UNIVERSITY OF NORTH TEXAS
KERR HALL DINING RENOVATION
ISSUE FOR CONSTRUCTION

JANUARY 30, 2025

NO	DESCRIPTION	DATE
1	ADDENDUM 2	05.23.25

QF1.0
FS EQUIPMENT PLAN

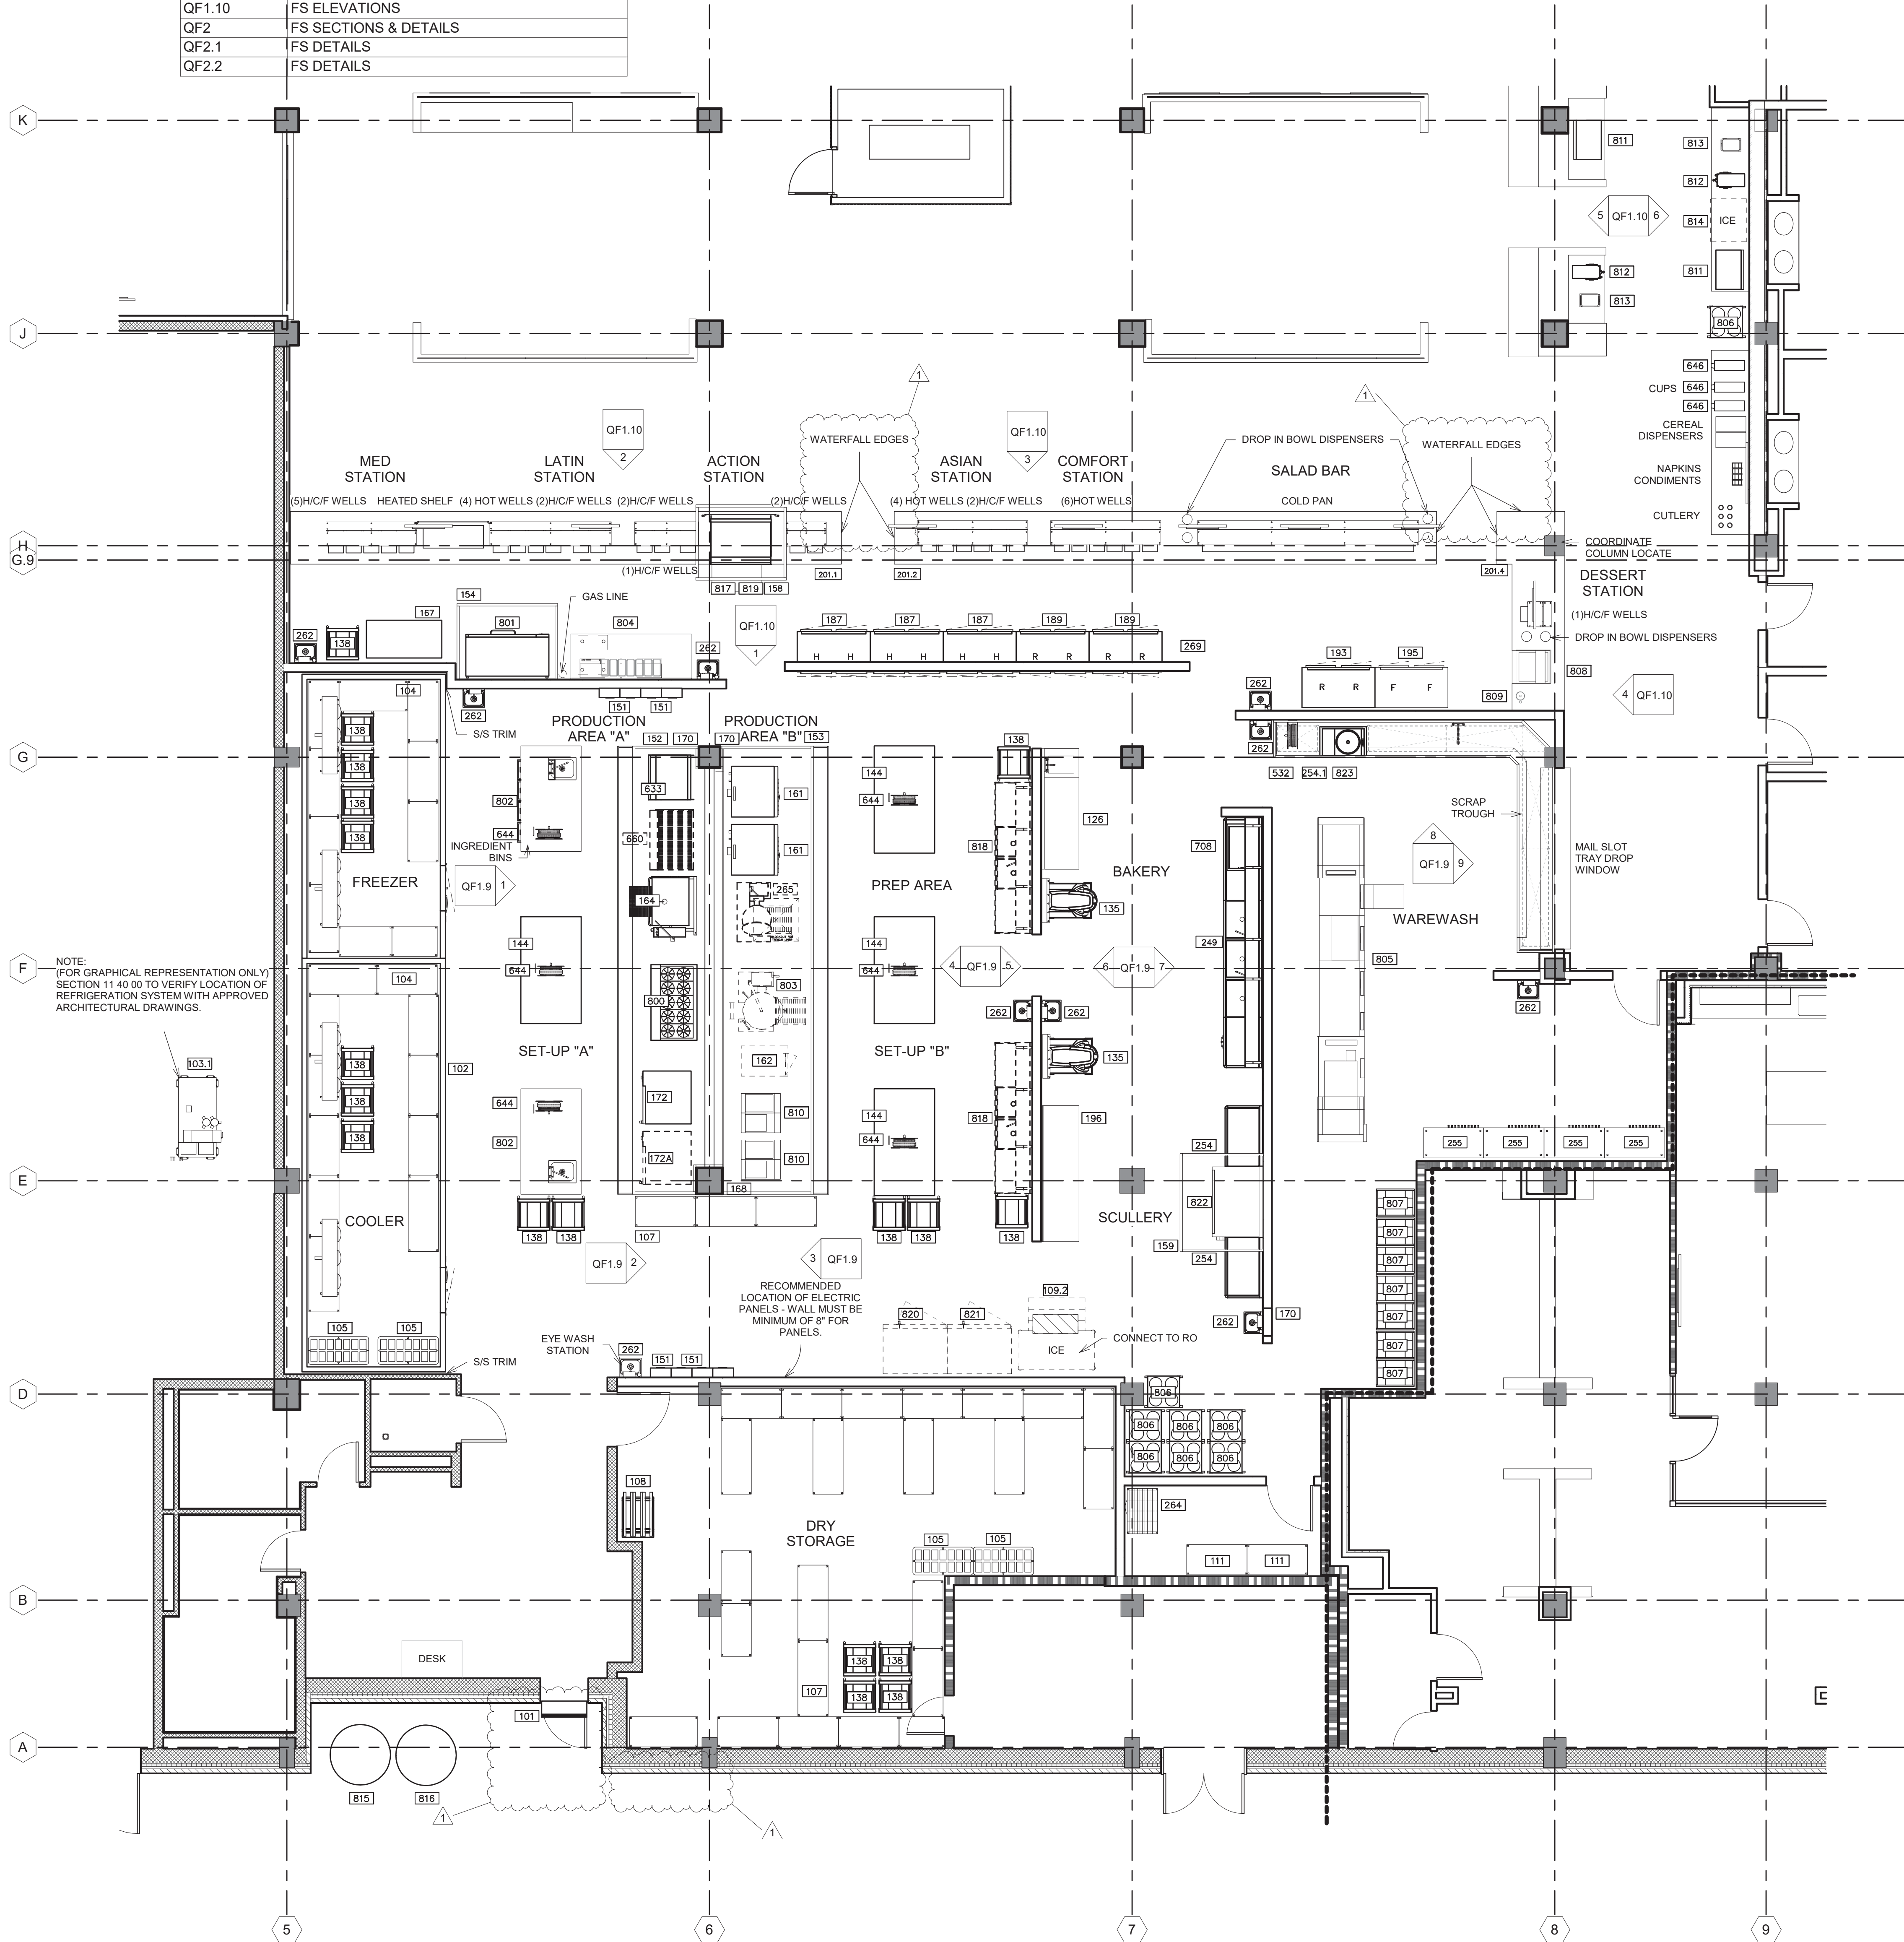
- ADDED WATERFALL EDGES TO SERVING COUNTERS
- REMOVED CANOPY AT RECEIVING DOOR
- REMOVED HOSE BIBB AT LOADING DOCK
- REVISED SIZE OF AIR SCREEN AT RECEIVING DOOR

PLUMBING ENLARGED PLANS AND RISERS

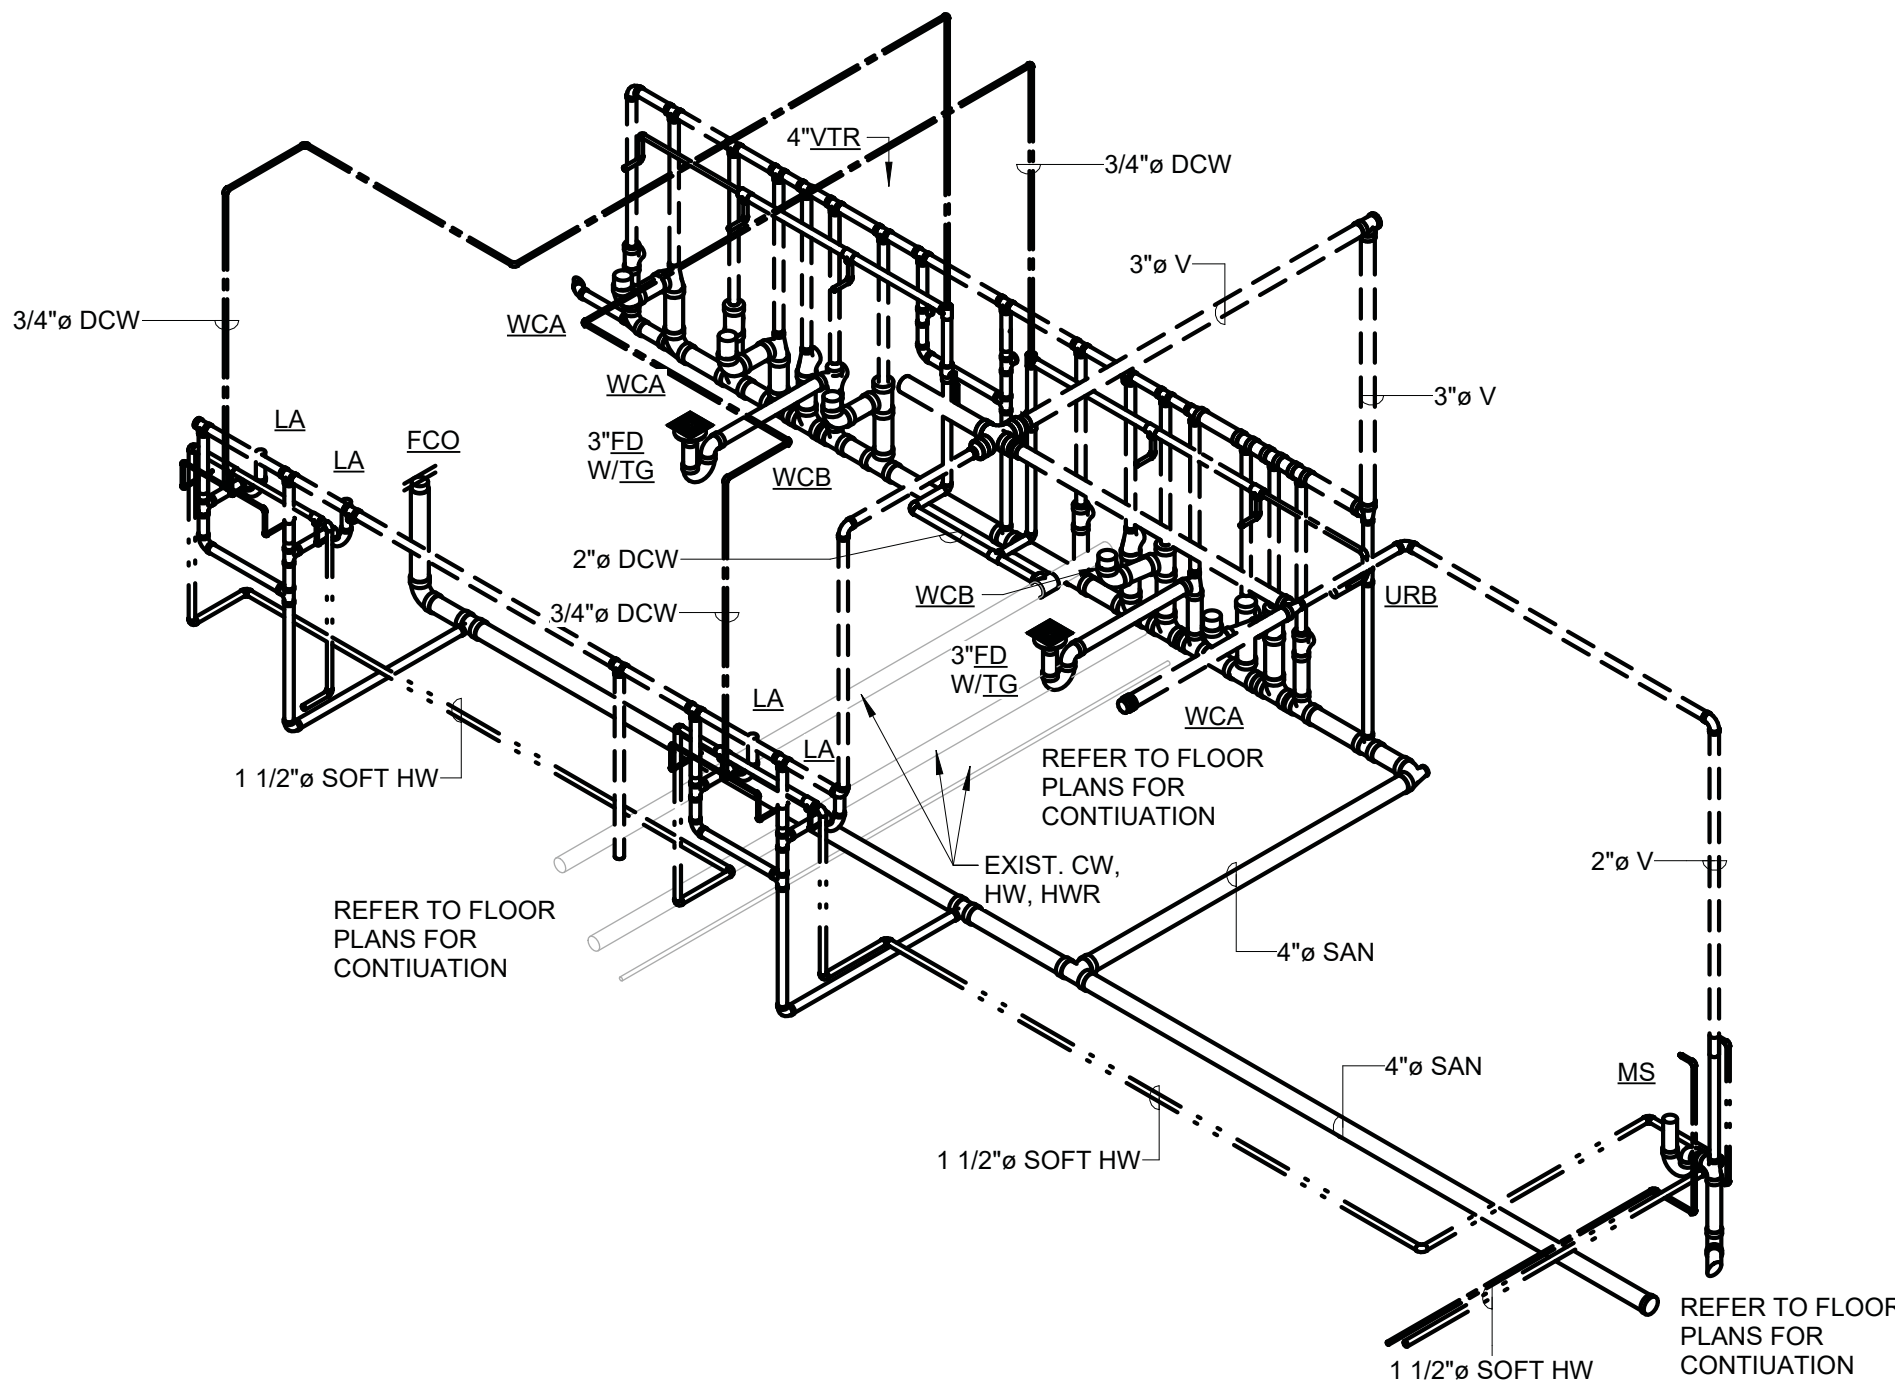
- REVISED VENT PIPING AND ASSOCIATED KEYED NOTE TO CONNECT TO EXISTING VENT THRU ROOF PER GC COMMENTS AND RESPONSES.

iE201B
LEVEL 1 ELECTRICAL PLAN - DINING
TreanorHL NO. HE0569 2302.01

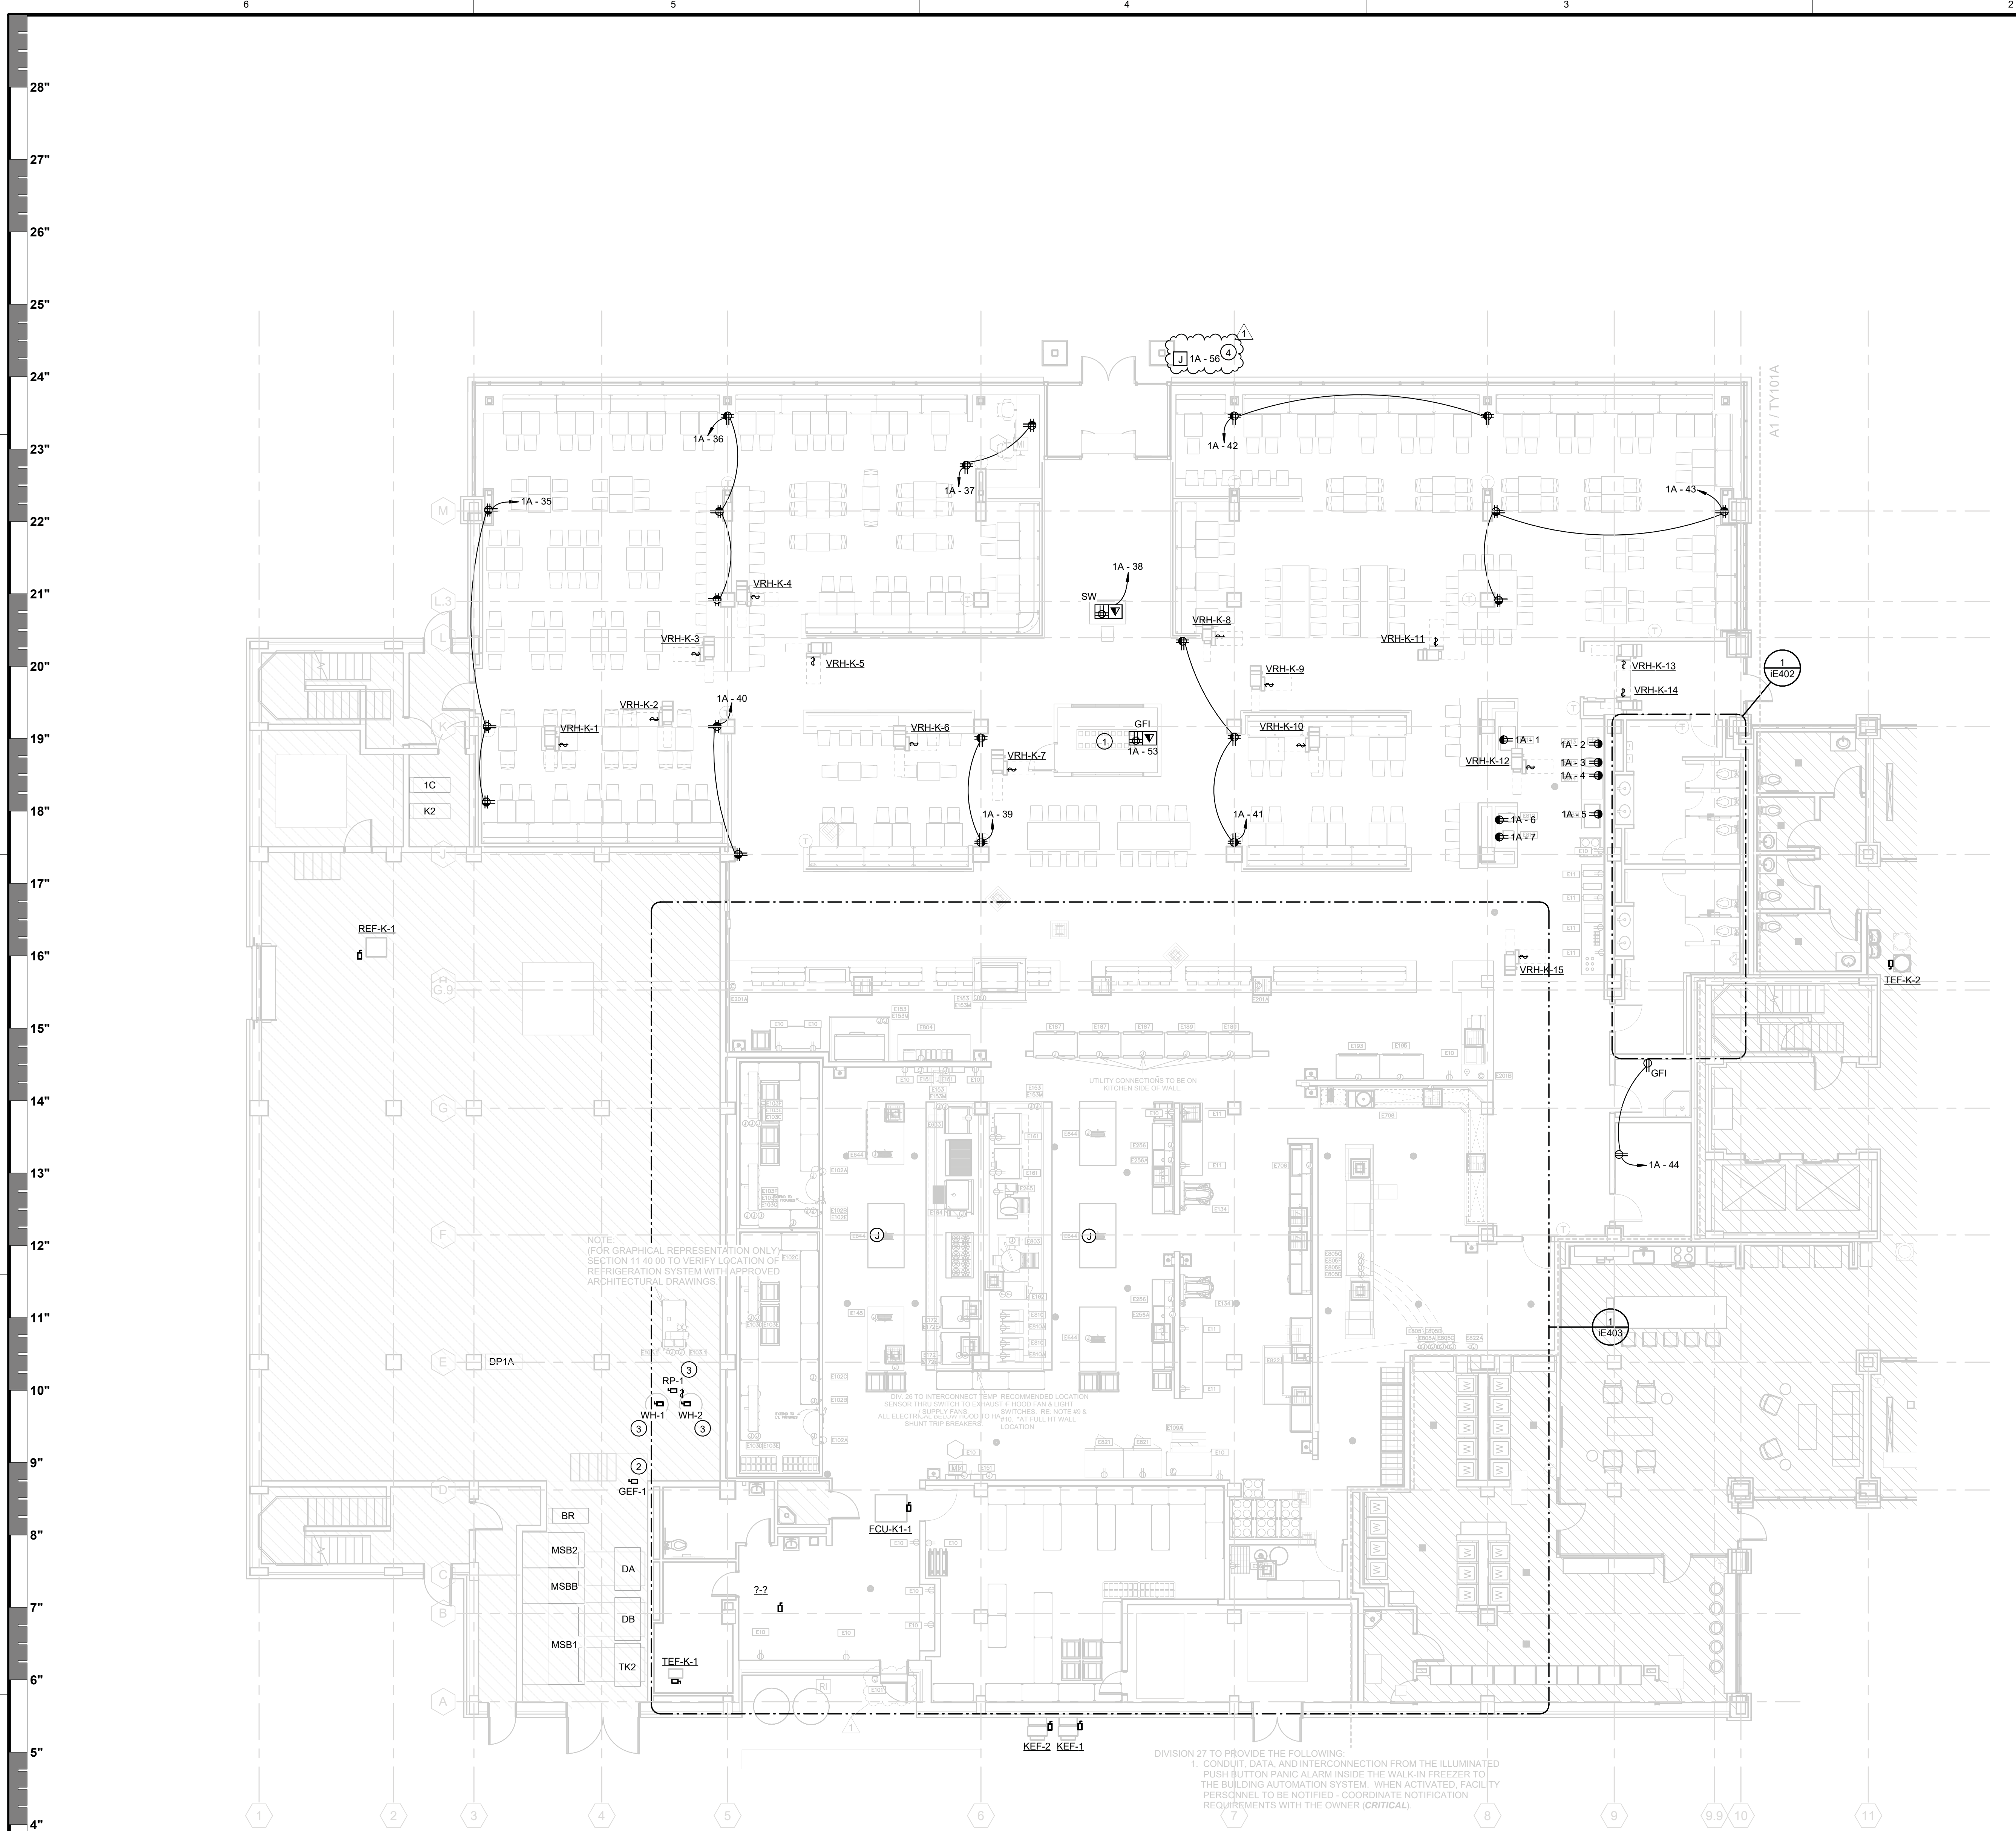
REVISION SUMMARY:
- ADDED JUNCTION BOX FOR INTEGRALLY-LIT EXTERIOR SIGN.
- ADDED KEYED NOTE 4.
